Vermont Agency of Transportation
RECEIVED
CK'D BY M.E.M. OK'D BY C.W.M.
July 09, 2012
RESUBMIT APPROVED AS NOTED
BY C. CARLSON DATE 07-27-2012

FOR APPROVAL			
REVISION	DATE	PAR	VER.
1	07/06/12	BR	EG
NOTE: BOLT 1 WASHER: 1 WASHER UNDER NUT U.N. BOLT 2 WASHER: 1 WASHER UNDER HEAD U.N. 1 WASHER UNDER HEAD U.N.			
PROJECT: VT RT 9, BRIDGE NO. 11 TOWN OF WOODFORD, VT OVER WALDOOMSAC RIVER			
TITLE: GIRDER 102G1			
REFERENCE: PROJECT NO. ER BHF 010-1 (44)			
BR	JULY 2012	UN04260	
GG	JULY 2012	102-2

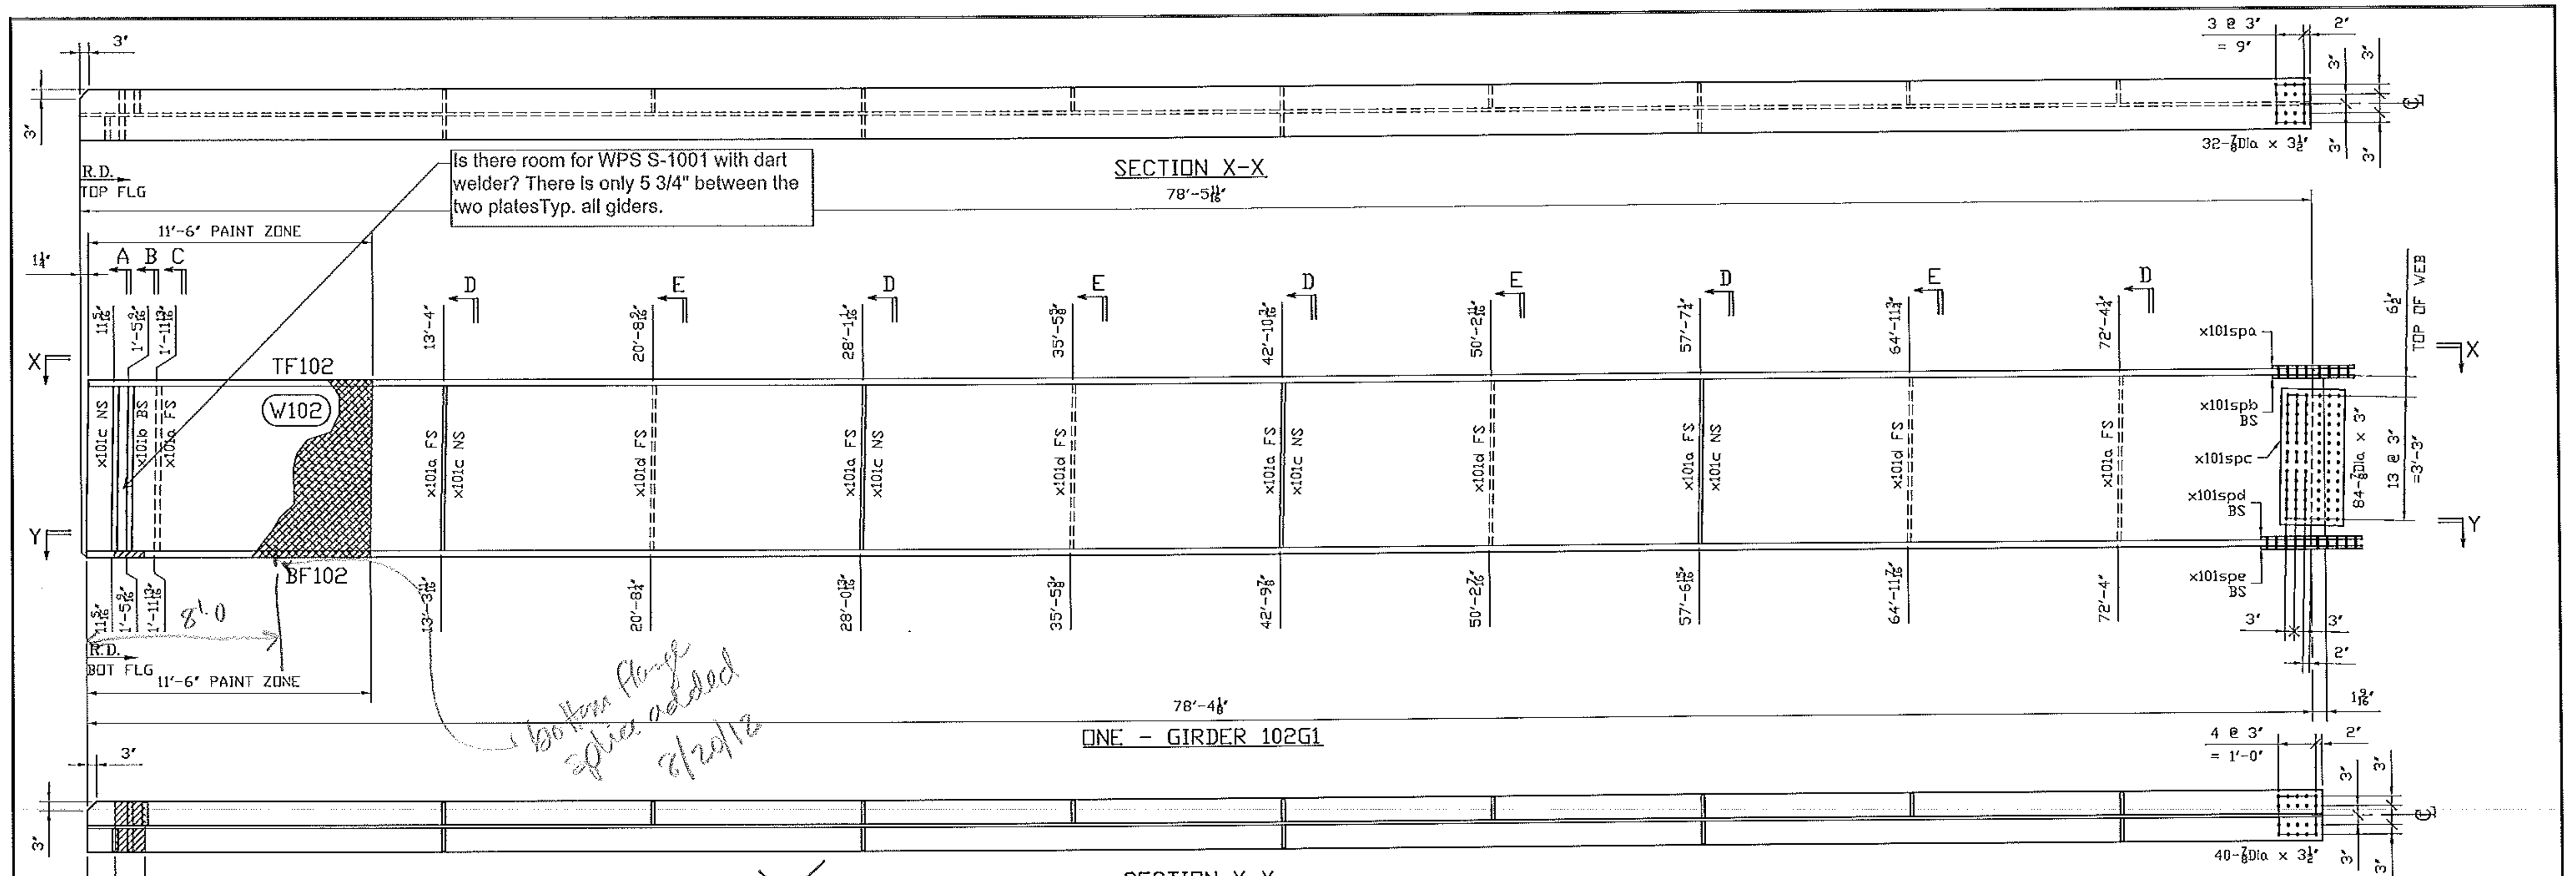
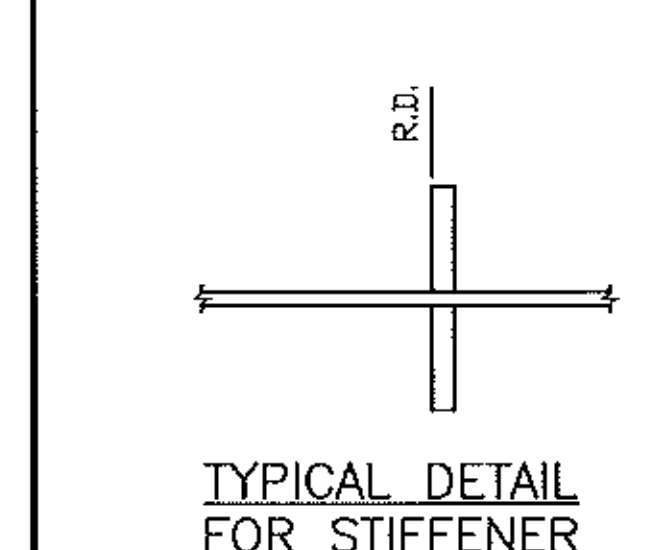
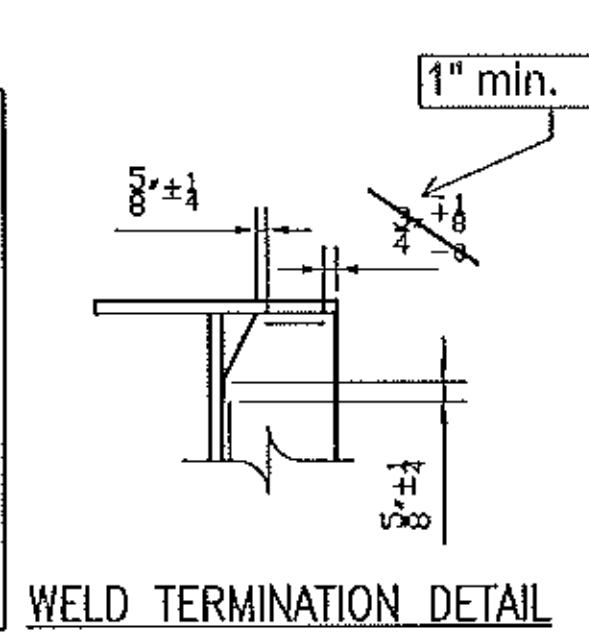
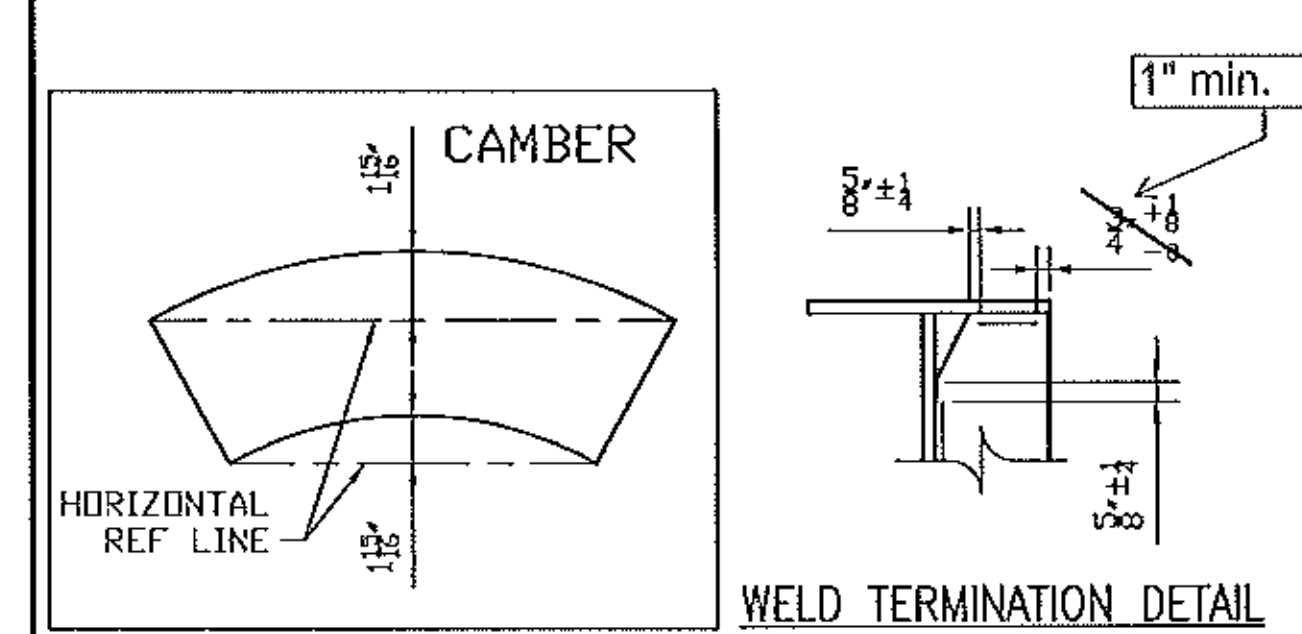
THE FIELD SPLICE PLATES MUST NOT EXCEED THE END OF GIRDER

See standard specification 506.24(a)(9), no payment will be made for bolts, nuts, washers, they are considered to be incidental
